A d d e n d u m

Iowa Department of Transportation
Office of Contracts

B.O.	Proposal ID	Proposal Work Type	County	Project Number	Addendum
001	08-C008-039	Bridge and Approaches – PPCB	Boone	IBRC-C008(39)--8E-08	18apr001.a02

Abutment keyway dimensions

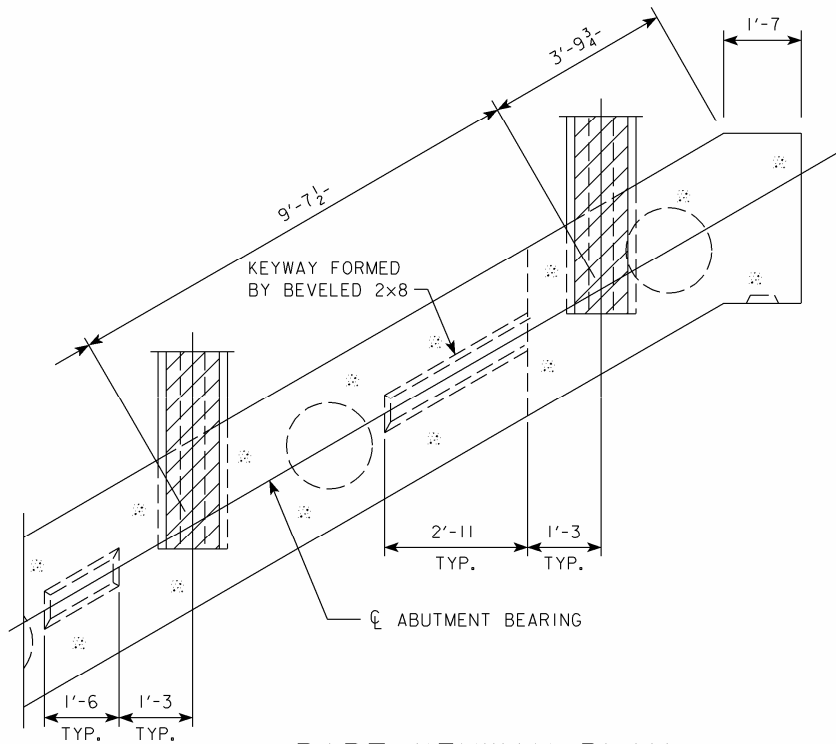
PART KEYWAY PLAN

Location of vertical reinforcing in the abutment

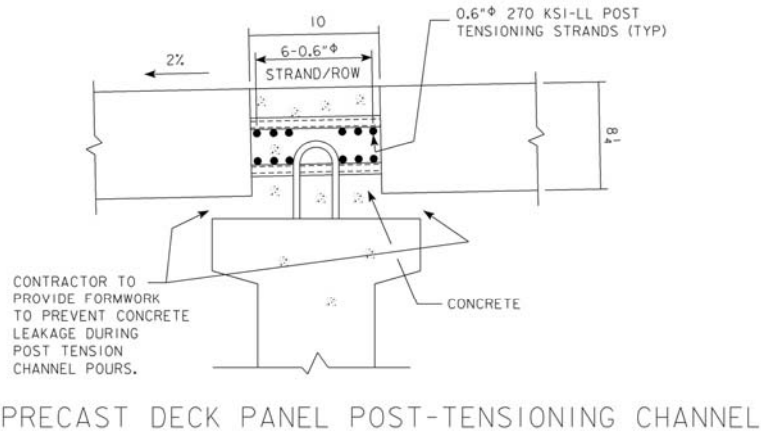
In the precast abutment footing the vertical 8g5 and 8g4 bars are to be placed with a minimum of 2" clear cover. The 8f1 longitudinal bars are to be placed interior of the vertical bars (towards the center of the precast footing each face).

Detail: Beam / Panel Joint – Contractor to prevent concrete leakage.

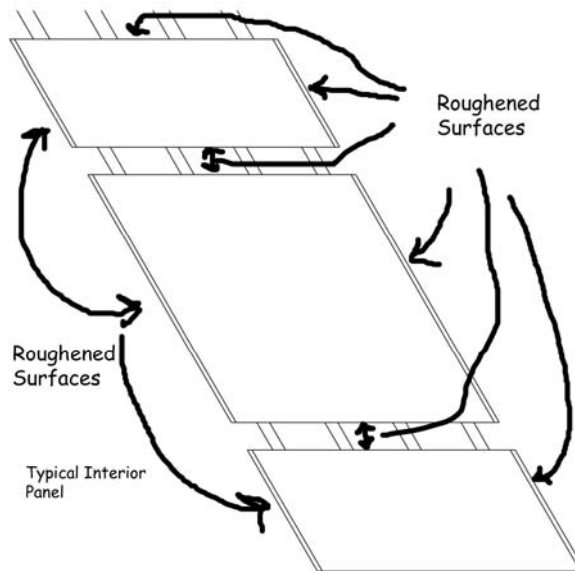
The plans, on Design sheet #19, incorrectly shows formwork intended to prevent leakage of concrete at the beam/panel joint. The method of preventing concrete leakage at the joint is left to the contractor. The correct detail is shown below.
